COLORADO DIVISION OF RECLAMATION, MINING AND SAFETY
MINERALS PROGRAM INSPECTION REPORT
PHONE: (303) 866-3567

MINE NAME: Neglected Mine	MINE/PROSPECTING ID#: M-1981-165	MINERAL: Gold	COUNTY: La Plata
INSPECTION TYPE: Monitoring	INSPECTOR(S): Kate A. Pickford	INSP. DATE: September 25, 2012	INSP. TIME: 12:30
OPERATOR: Mine Development Inc	OPERATOR REPRESENTATIVE:	TYPE OF OPERATION: 110(2) - Hard Rock Limited Impact	
REASON FOR INSPECTION: Normal I&E Program	BOND CALCULATION TYPE: Complete Bond	BOND AMOUNT: \$23,221.00	
DATE OF COMPLAINT: NA	POST INSP. CONTACTS: None	JOINT INSP. AGENCY: None	
WEATHER: Cloudy	INSPECTOR'S SIGNATURE: 	SIGNATURE DATE: October 10, 2012

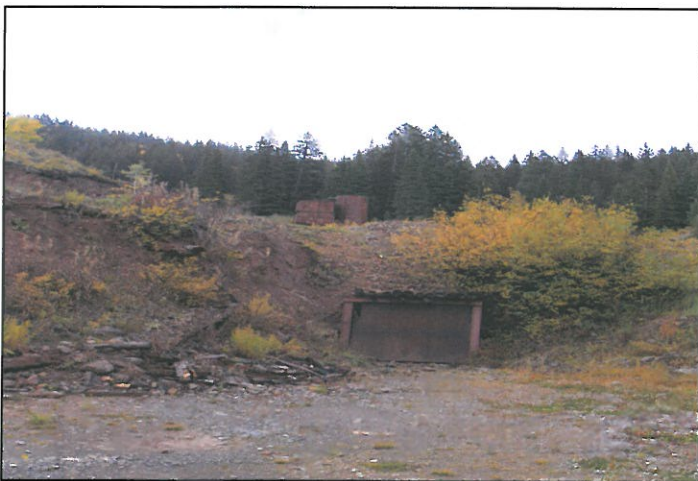
The liner in the talings pond has at least one hole in it, above the current water level. The pond has cattails, dirt, and rock in it that is visible from above the water line, and presumably has more material underwater. The integrity of the liner is in question due to its above water condition and the lack of maintenance.

The site is well maintained and safe. According to Division records, the site has been inactive for at least 4 years. Therefore, the operator must supply the Division with a revision, placing the site into Temporary Cessation, or submit information to the Division indicating that activity will resume within the next year and a plan to restart operations at the site. Part of this plan must include how the operator will establish, to the Division that the tailings pond liner is still an impermeable and effective barrier.
